HETCH HETCHY WATER TREATMENT PROJECT CHLORAMINE CONVERSION

Environmental Impact Report

*San Francisco Planning Department File No. 1998.898E
State Clearinghouse No. 199912090*

File No.: 1998.898E: Hetch Hetchy
Water Treatment Project - Chloramine
Conversion

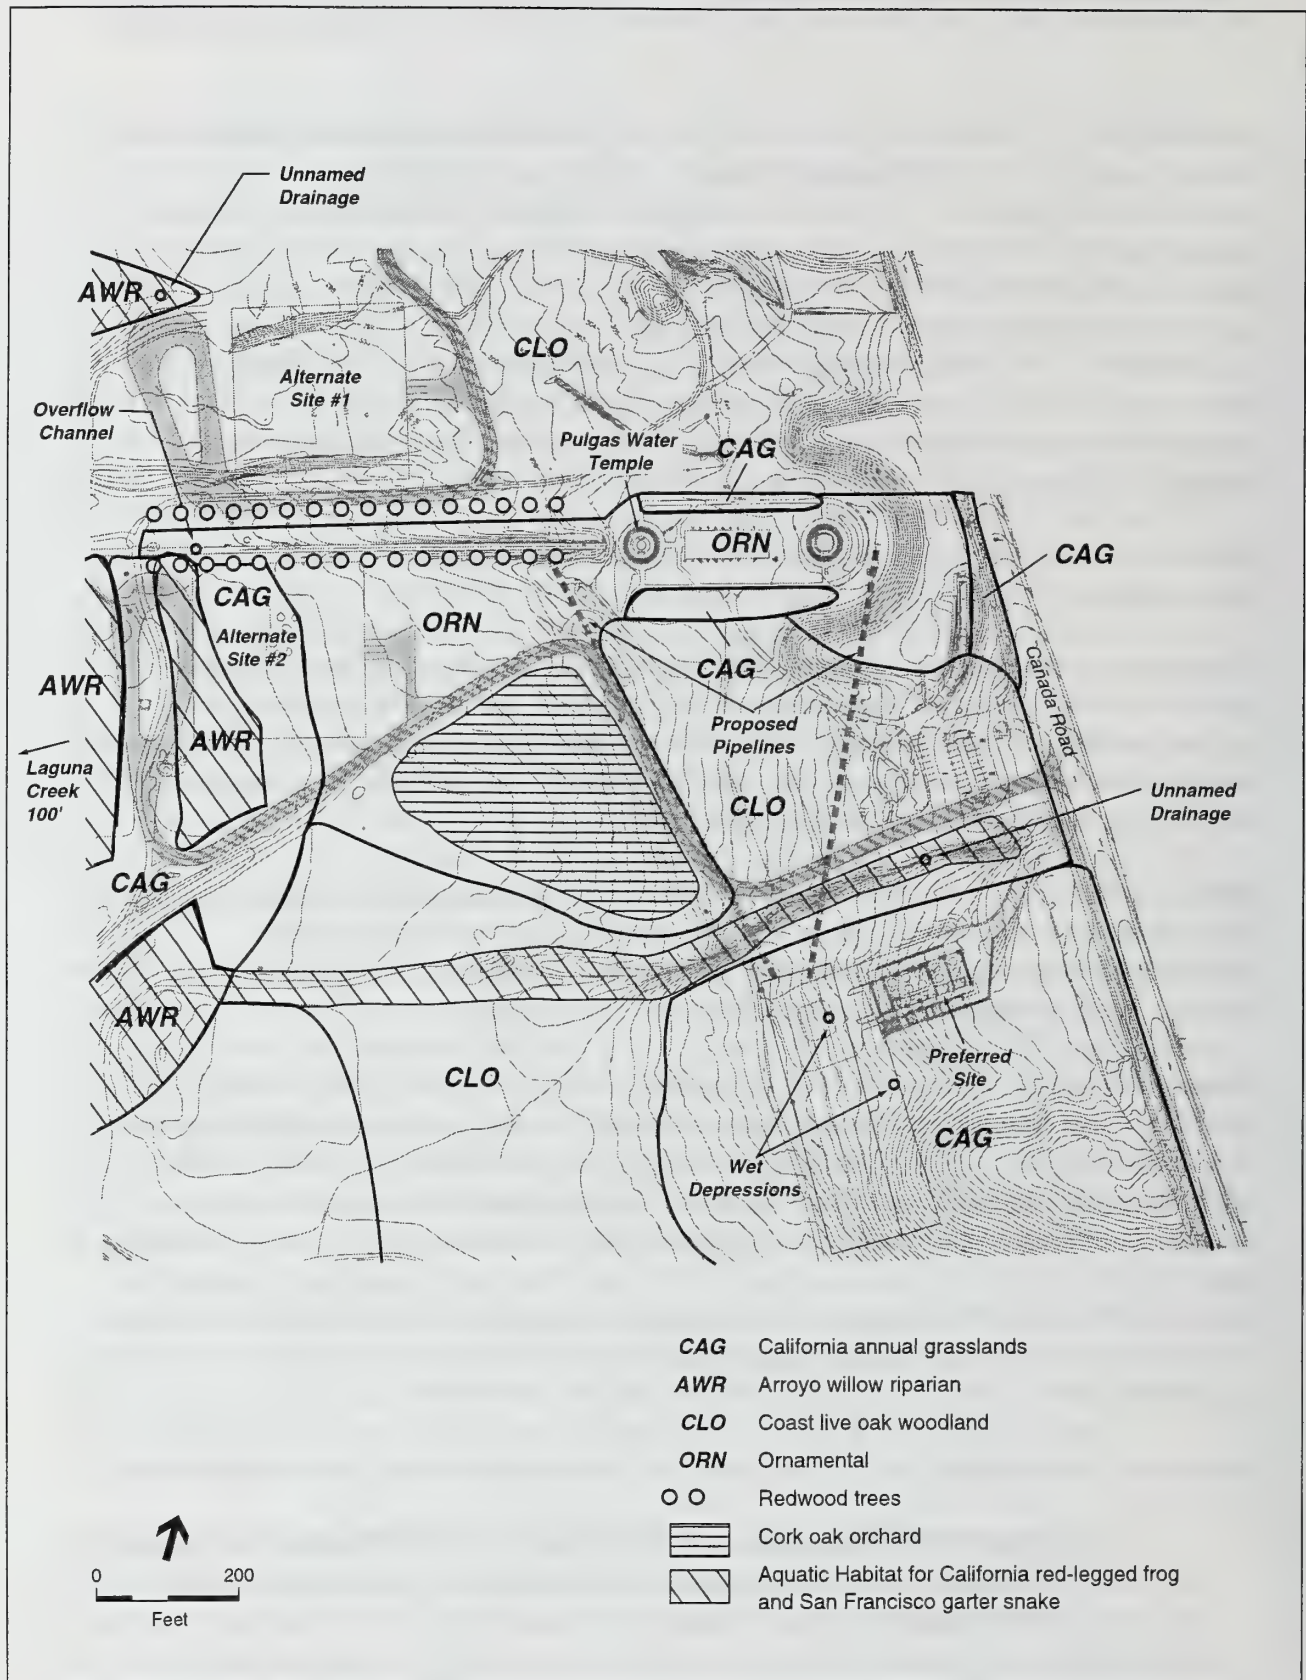
Comment F-4: "Special Status Species- The EIR states that San Francisco garter snake and California red legged frog are likely present on the project site and could be impacted during construction of the project. Measure C-6d. states that construction fencing to keep frogs and snakes from the construction area may be used if 'practicable'. No other alternate measures are identified if it is determined that this is not 'practicable'.

Additional measures for construction impacts must be identified and included in the EIR to make a finding that the project would result in less-than-significant impacts to these species. Identification of these measures is critical given the likelihood of impacts to the garter snake, as illustrated by the BART extension construction." (City of San Mateo)

Response: Comment F-4 is noted, and Mitigation Measure C-6d will be revised, as noted below. In addition, other means of excluding these species could be implemented in coordination with the U.S. Fish and Wildlife Service (USFWS). Such a situation could arise, for example, where the terrain changes abruptly, such as in a creek bed. In a case such as this, other means of excluding these species from the construction zone would be implemented. This may include the use of 4-foot-tall silt fences buried to a depth of 6 inches. While not as sturdy or permanent, this solution could temporarily function as well as plywood sheets. Any selected exclusion method(s) (including the use of plywood sheets) would be approved by the USFWS prior to their implementation.
